Verhoeff M2014025 Boundary Markers

REGULAR 112 PERMIT APPLICATION
ALL RITE PAVING AND RED-MIX - LAMAR DIVISION

VERHOEFF GRAVEL PIT #1
BENT COUNTY, COLORADO

RE: Verhoeff M2014025 Boundary Markers

EXHIBIT C-3

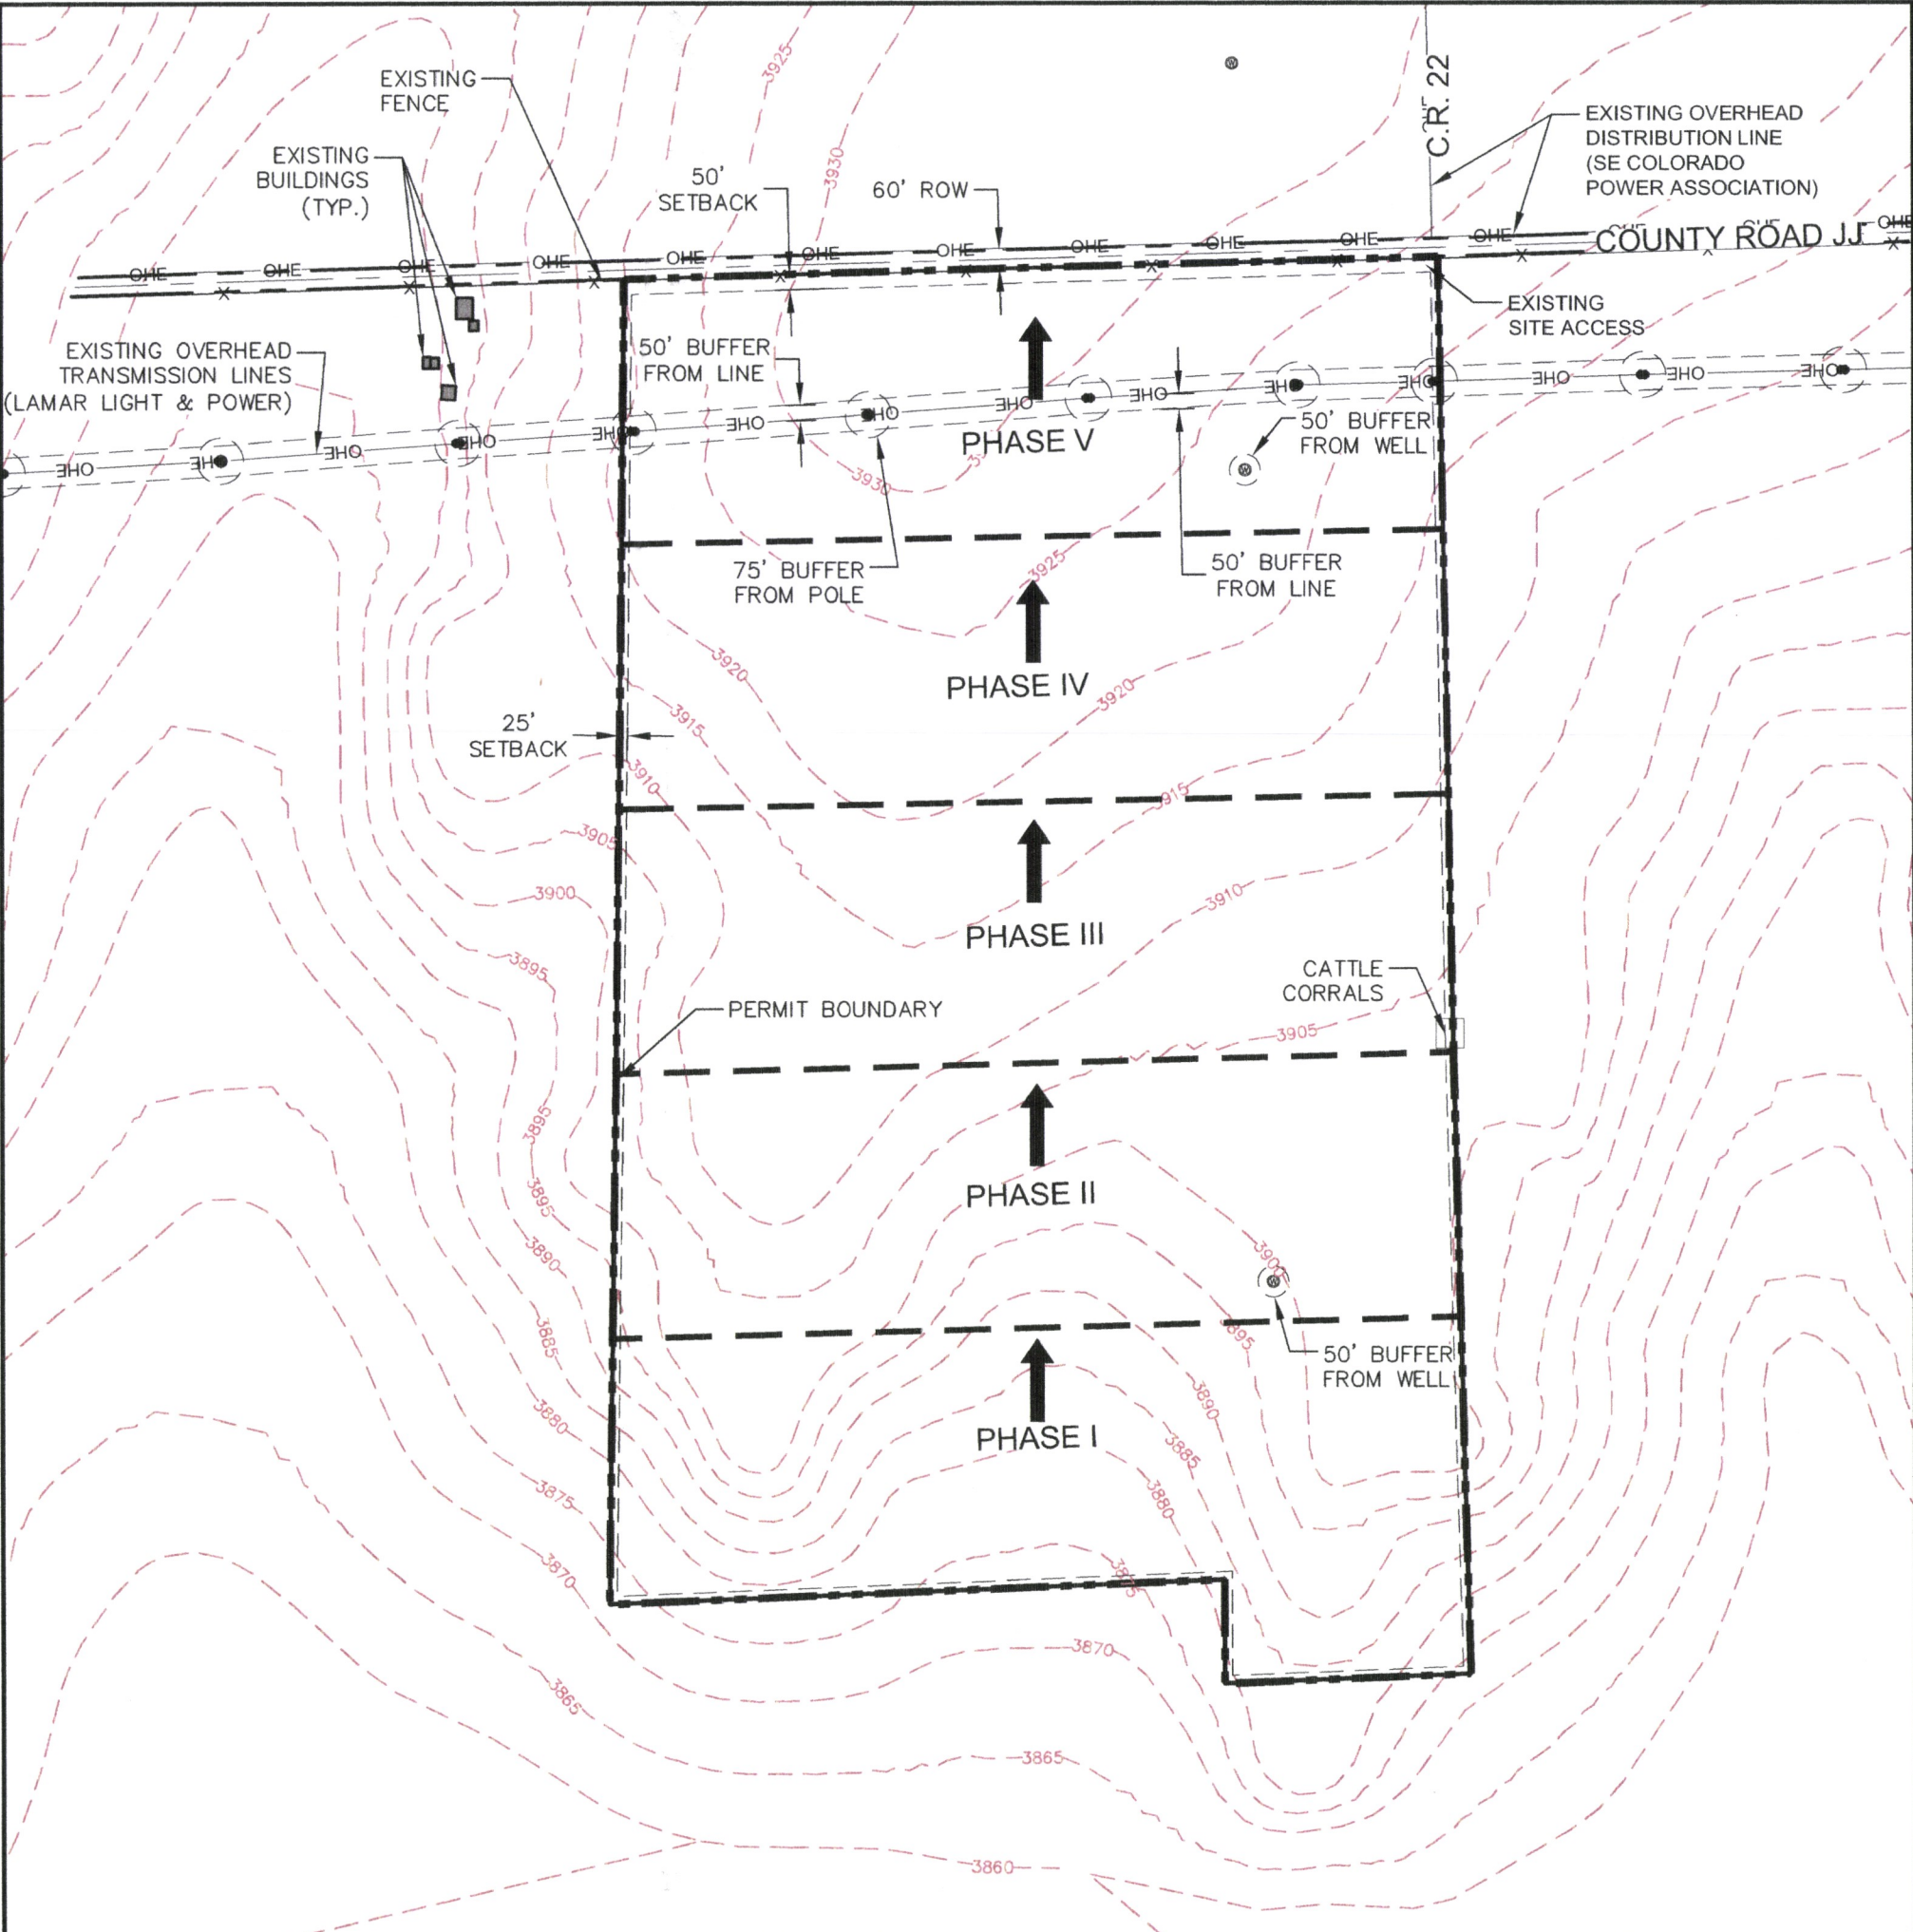
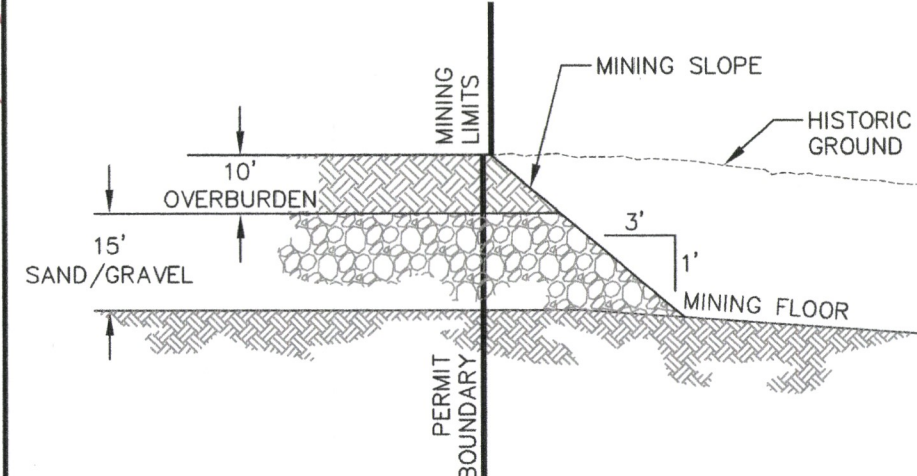
We were also unable to field located the well depicted in between Phase 1 and Phase 2. I am unsure what we should do at this point. Our coordinates should have put us within 10 feet of the well, but we could not locate it.

I pulled up the DWR well permit viewer. According to the data online, the well was permitted in 2009 but it wasn't constructed. That would explain why you only found the well in the north end of the permit area. The description states the well is 3300 feet from the north section line and 660 feet from the east line. Based on Google earth imagery of Section 34, the mine is 1500 feet from the east section line so you are not mining close to the proposed location of the

well. Verhoeff Farms is the permittee for the well. You may want to confirm with them that the well was never constructed.
